WYOMING LIBRARY REMODEL

Job No. 6943.03

AS PER ADDENDUM #1

RECORD SET OF DRAWINGS

KEYED NOTES

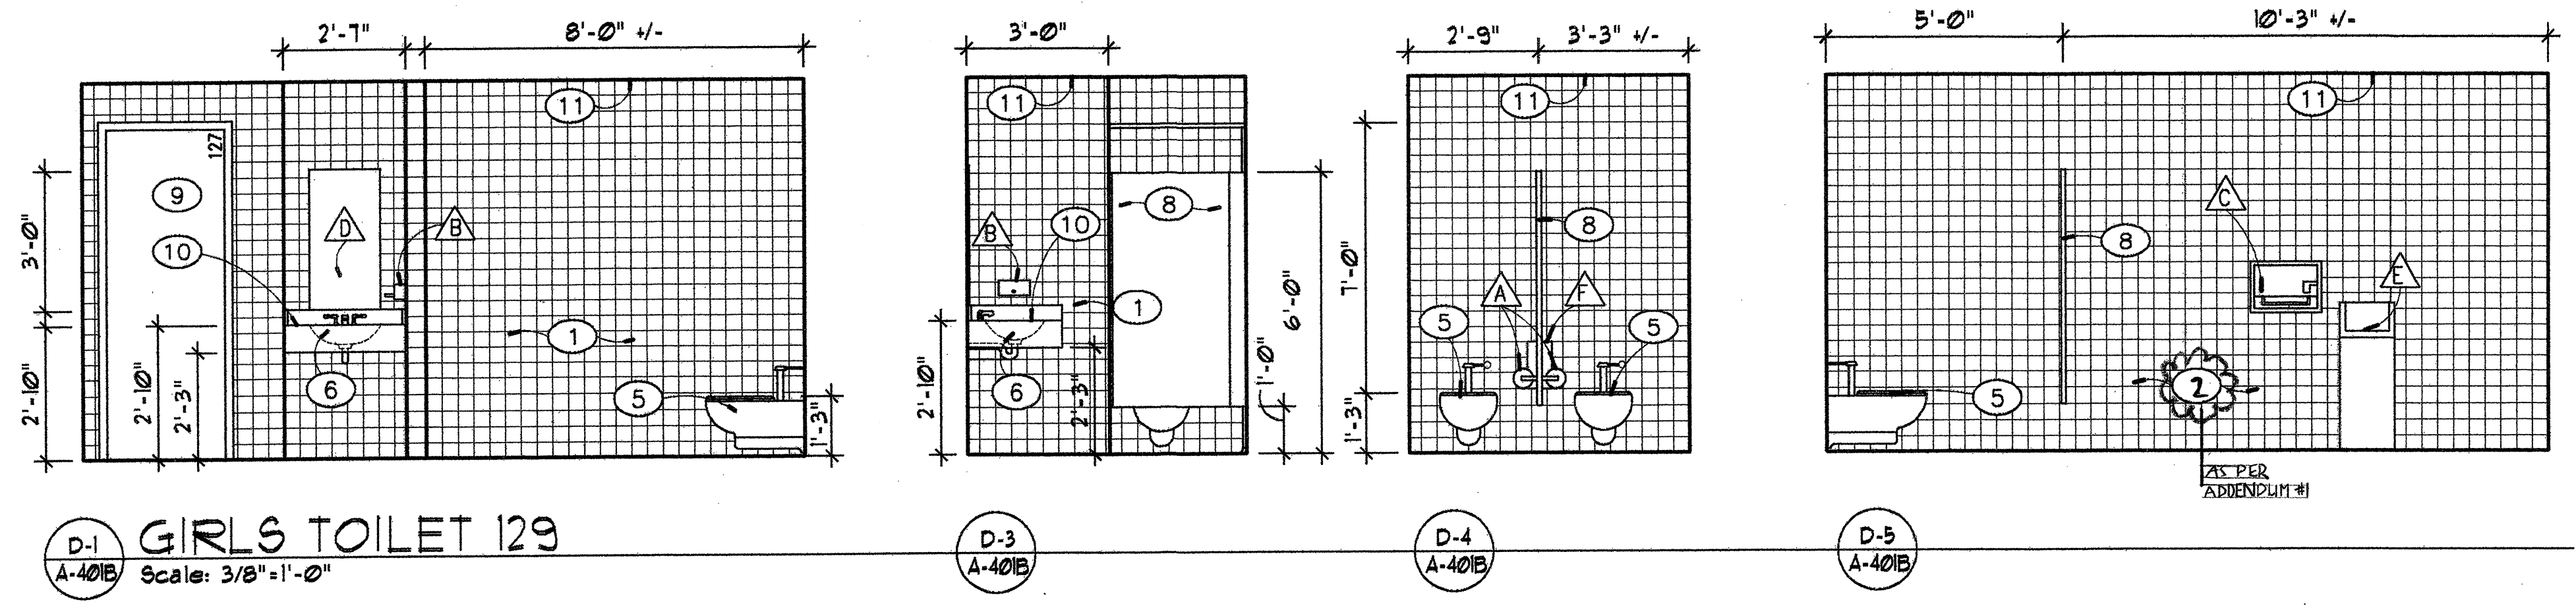
2. KN #3 indicates new 5/8" W.R. Type "X" gyp. brd., tape, texture and paint. It has come to our attention that the restrooms existing gyp. brd. may be reused. We do not want the new ceramic tile installed on just the painted walls. Provide thin chicken wire and staple to the wall to the studs so that the tile and thin set can adhere to the wall, not the paint. This is a tremendous savings in gyp. brd. work, please demo the wall and reinstall as indicated by the 2'-7" dimension at no additional cost to the Owner.

C-1 Section
A-406 Scale: 1 1/2"=1'-0"

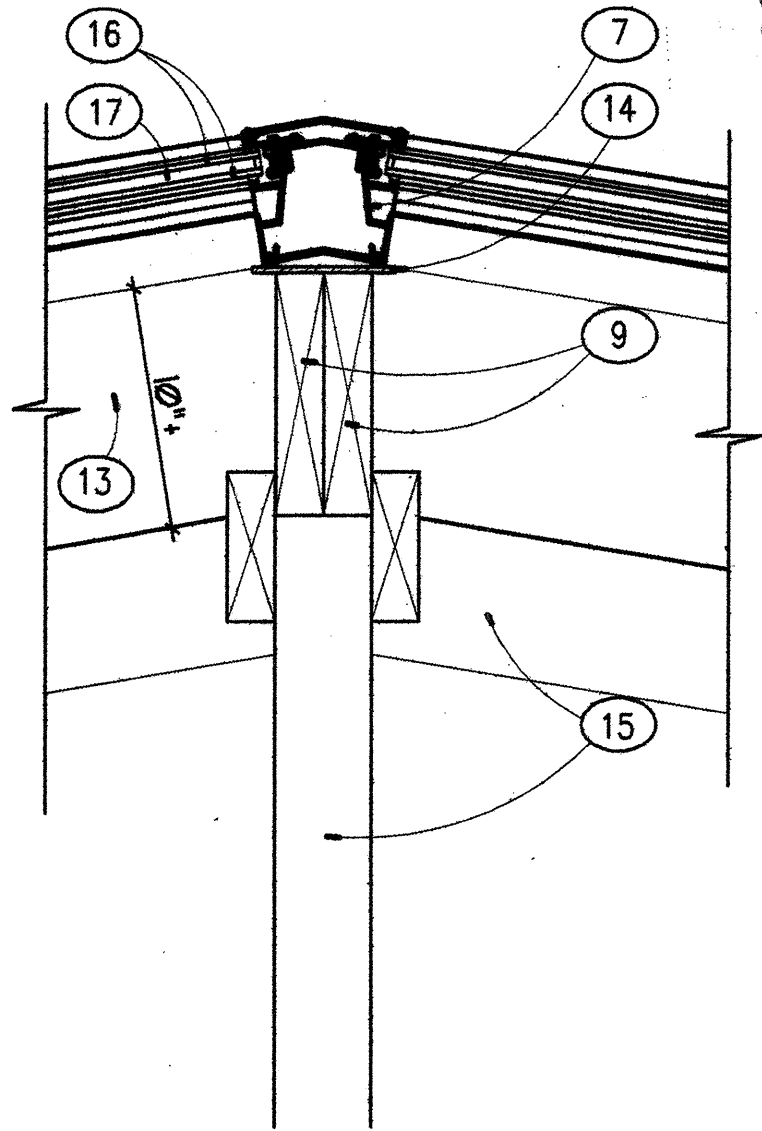
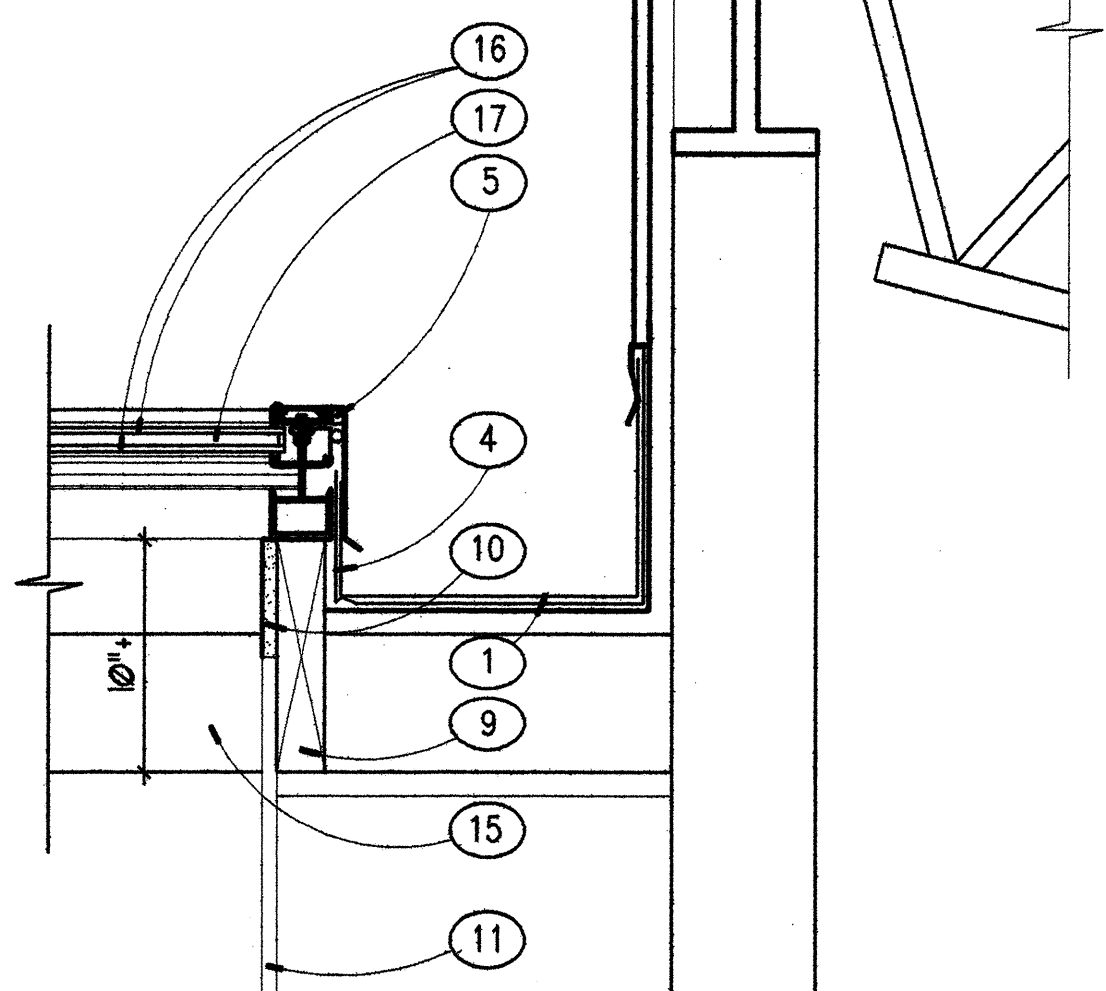
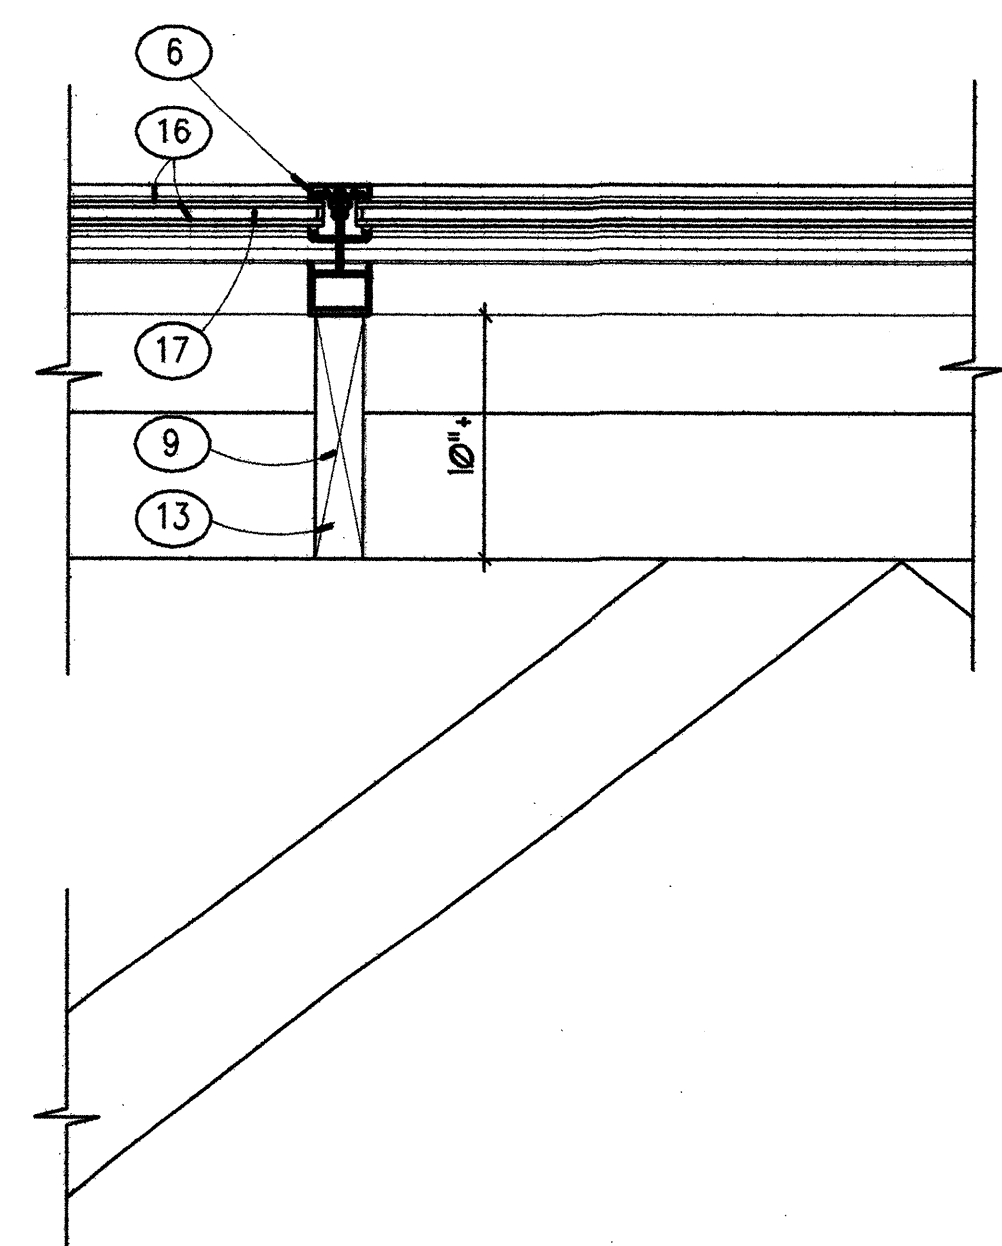
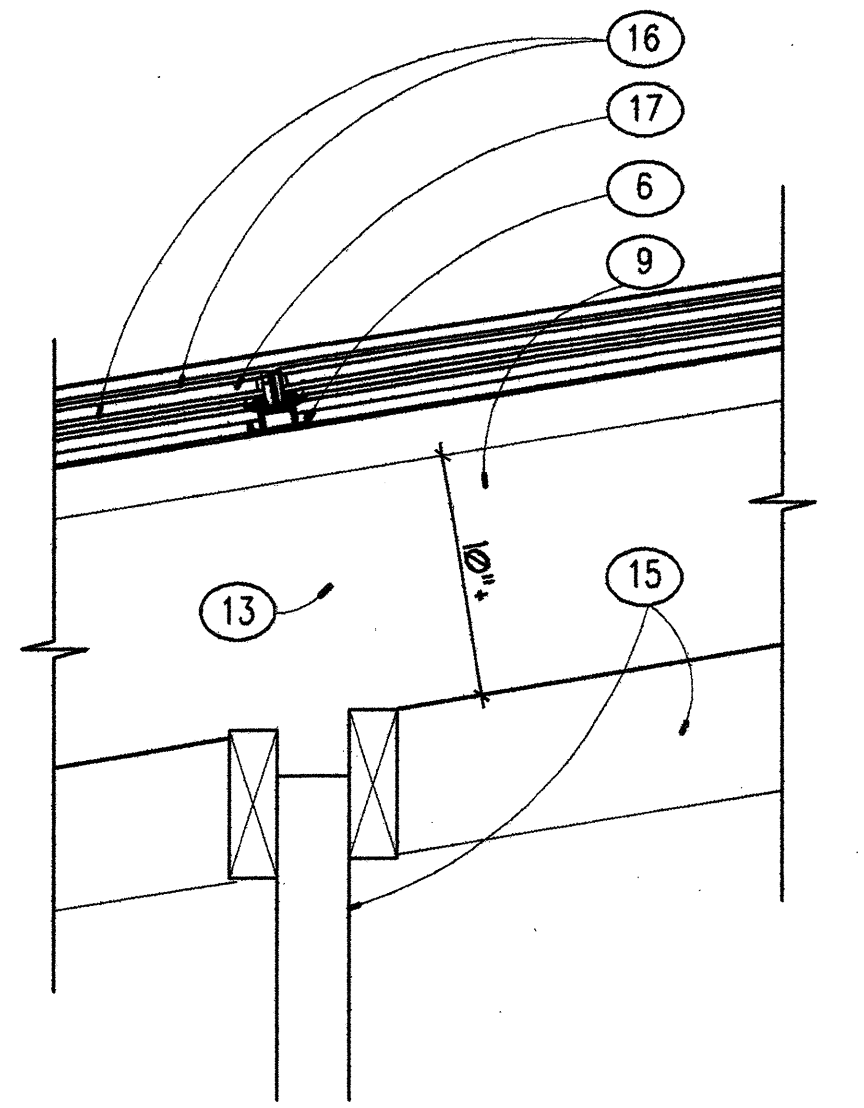
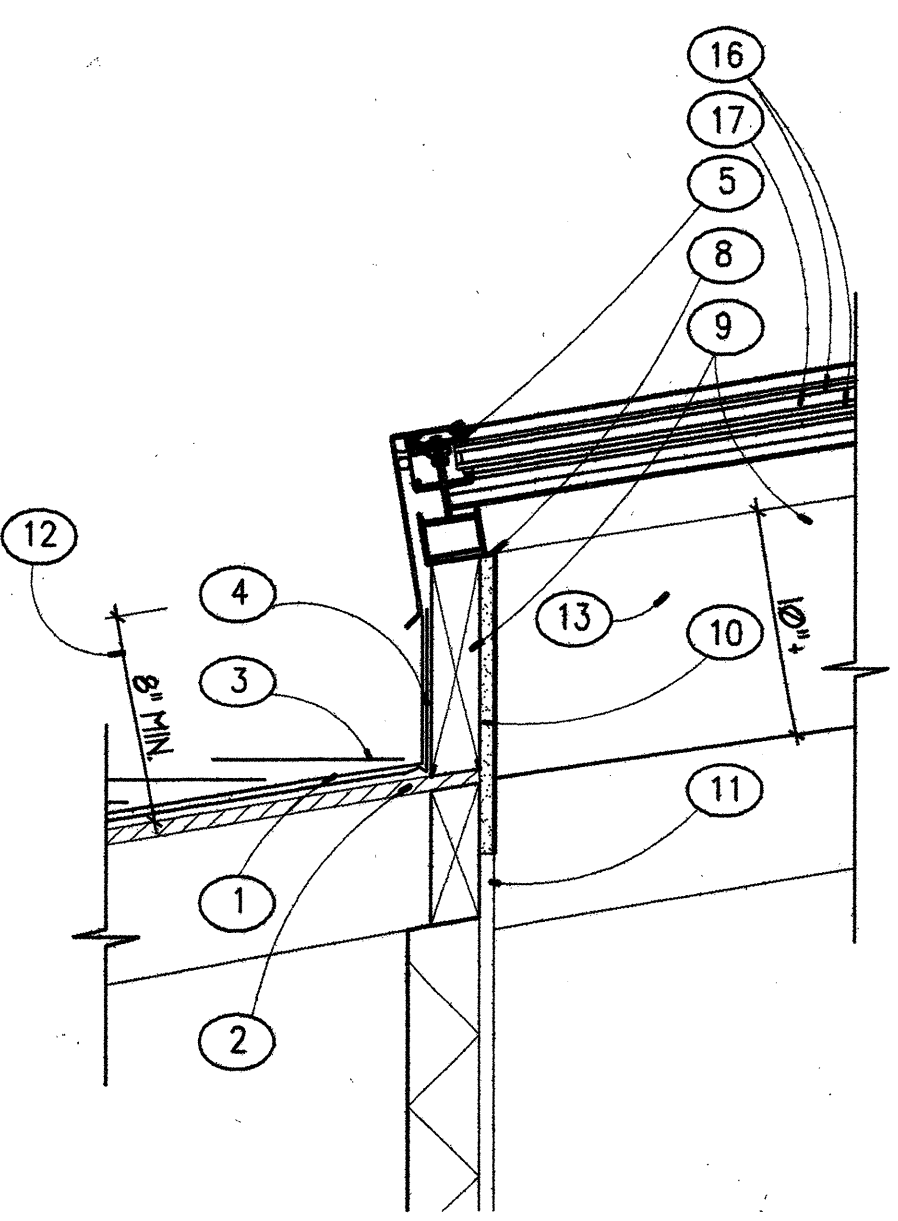
Sheet A-406 Clarification modification. The existing stucco has been brought down to within one inch of the existing shingles. It is terminated with a j metal and we assume metal flashing underneath. Leave the j-metal and flashing in place when removing the existing shingles. Provide new snow and ice barrier and metal flashing as shown running up the stuccoed wall. Add a new surface mounted counter flashing on the stuccoed wall with sealant. This detail will occur where the shingles run into all the stuccoed walls in base bid and alternate No. 2.

A-2 Roof Plan
A-406 Scale: 1/8"=1'-0"

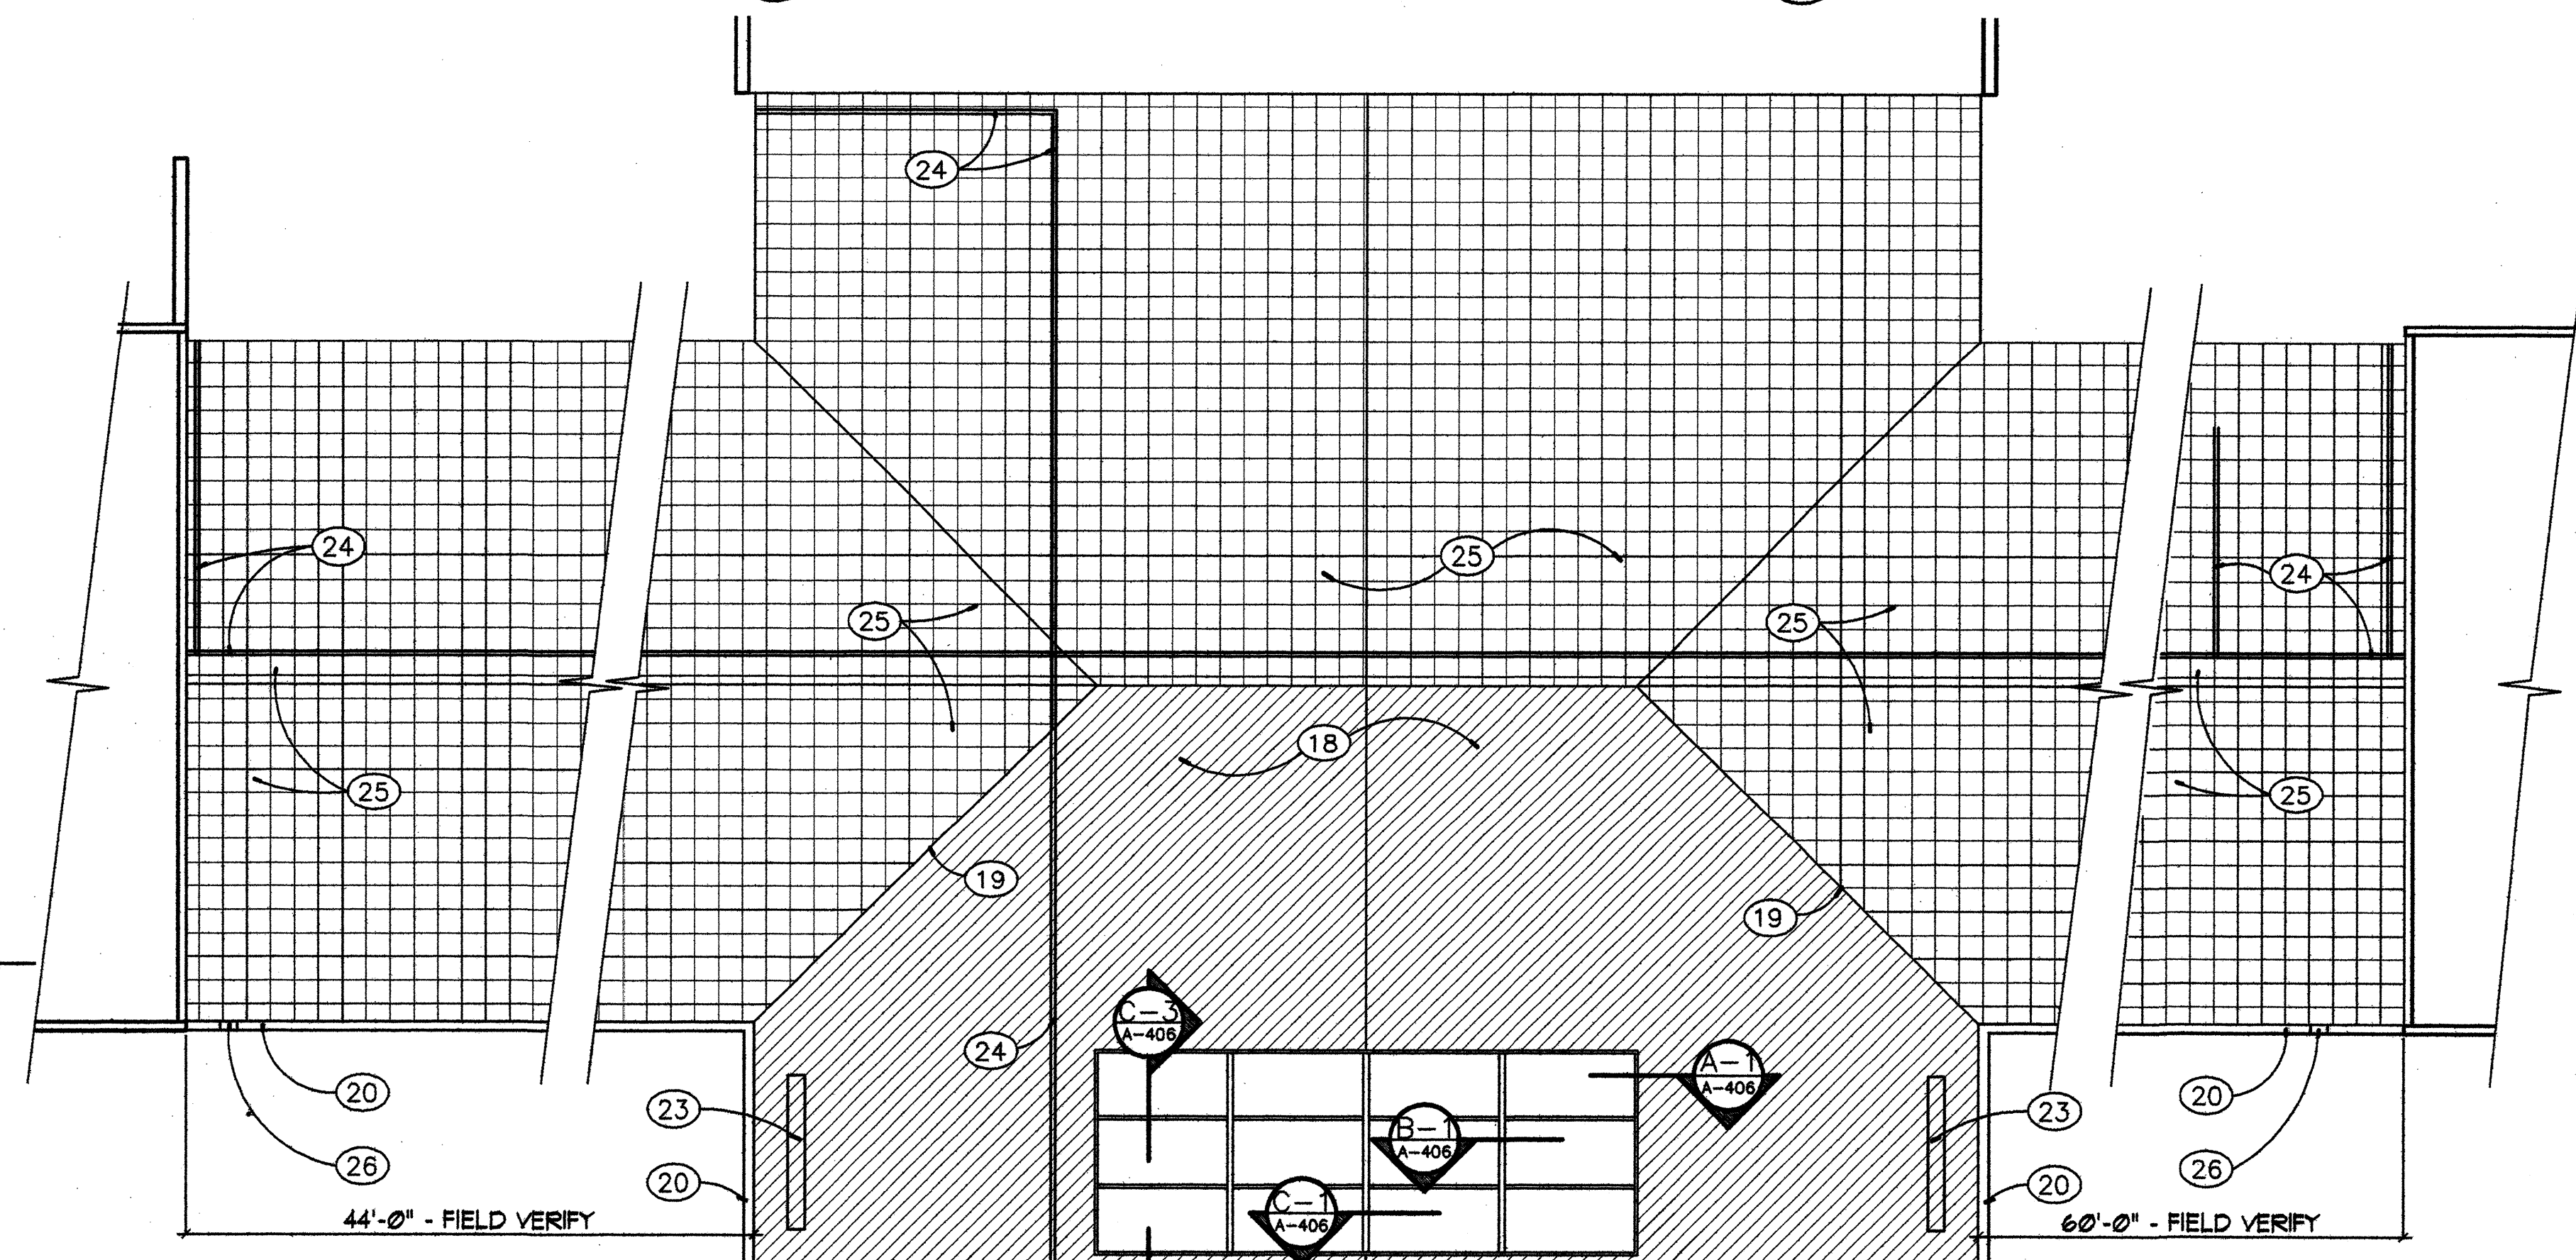
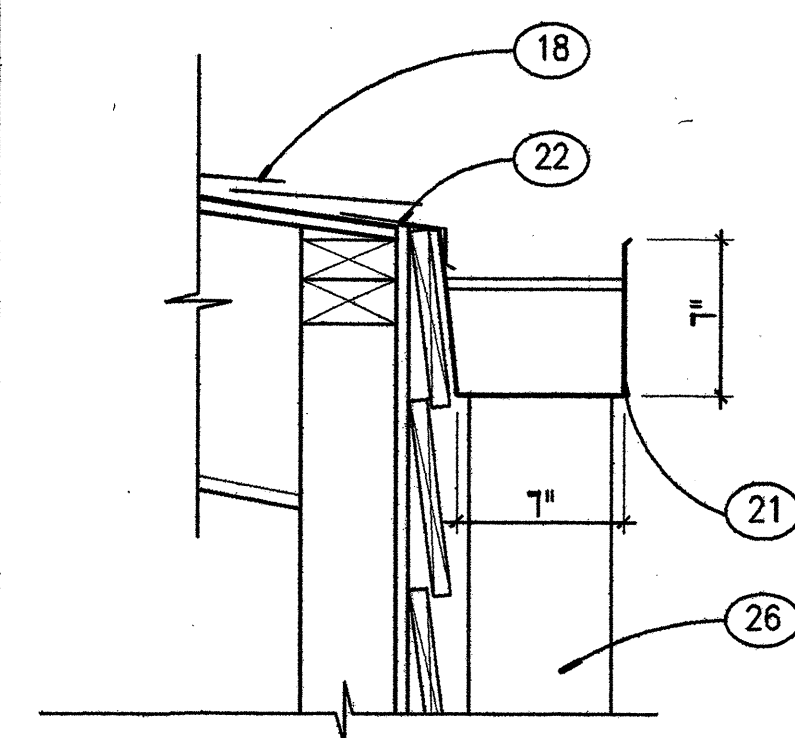
Roof Plan A-2/A-406 Keyed Note 19 will apply at the valleys in Alternate No. 2. Note all ridges will be flashed for manufacturers standard details in Alternate No. 2.
